Access Compliance Report

Public Rights-of-Way

(Curb Ramps)

Intersection ID: 45522	Main Street: LANSFORD_RD	Cross Street: WILBURN_CT	Location: E
ADA ID: F28A0281DD2D	Ramp Type: PerpDiag	Initial Pass/Fail: Fail	Overall Compliance: No
Severity Score: 13.75			
Codes/Mitigation Info/Possible Solution		Field Measurements/Component Compliance

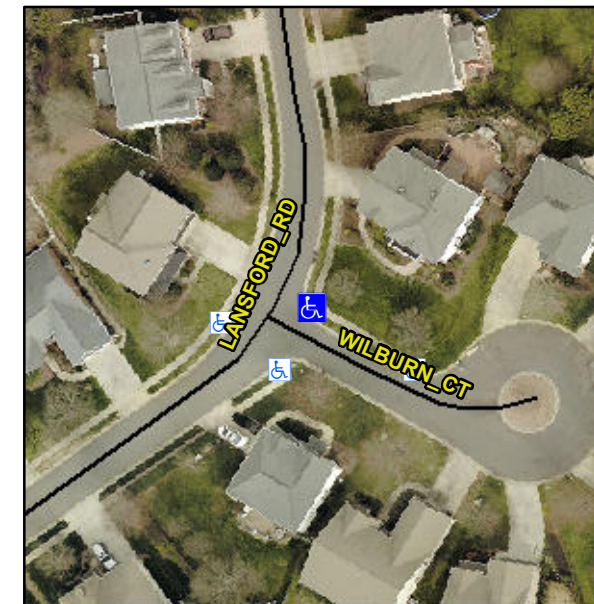
Not Found, R304.2.2, R304.5.3

Compliance	Description	Data	Compliance	Description	Data
N/A	Ramp Length (in)	45.0	No	Ramp Slope (%)	8.7
Yes	Ramp Width (in)	48.0	No	Ramp XSlope (%)	3.8
N/A	Flare Type LT	N/A	N/A	Flare Type RT	N/A
N/A	Flare Slope LT (%)	N/A	N/A	Flare Slope RT (%)	N/A
N/A	Flare Traversable LT?	N/A	N/A	Flare Traversable RT?	N/A
N/A	Landing Length (in)	N/A	N/A	DWS Provided?	N/A
N/A	Landing Width (in)	N/A	N/A	DWS Contrast?	N/A
N/A	Landing Slope (%)	N/A	N/A	DWS Length (in)	N/A
N/A	Landing X Slope (%)	N/A	N/A	DWS Full Width?	N/A
N/A	Landing Curb? (Y/N)	N/A	N/A	DWS Offset (in)	N/A
N/A	Shared Landing?	N/A			
N/A	Gutter Ponding?	N/A	N/A	Gutter Slope (%)	N/A
N/A	Gutter Lip Ht (in)	N/A	N/A	Gutter X Slope (%)	N/A
N/A	Painted X Walk1?	No	N/A	Painted X Walk2?	No
	X Walk 1 Direction	To NW		X Walk 2 Direction	To SW
N/A	X Walk 1 Width (in)	N/A	N/A	X Walk 2 Width (in)	N/A
	X Walk 1 Slope (%)	1.2		X Walk 2 Slope (%)	3.9
	X Walk 1 X Slope (%)	3.6		X Walk 2 X Slope (%)	3.2

Remove & Replace Curb Ramp With Two New Directional Ramps or Equivalent.
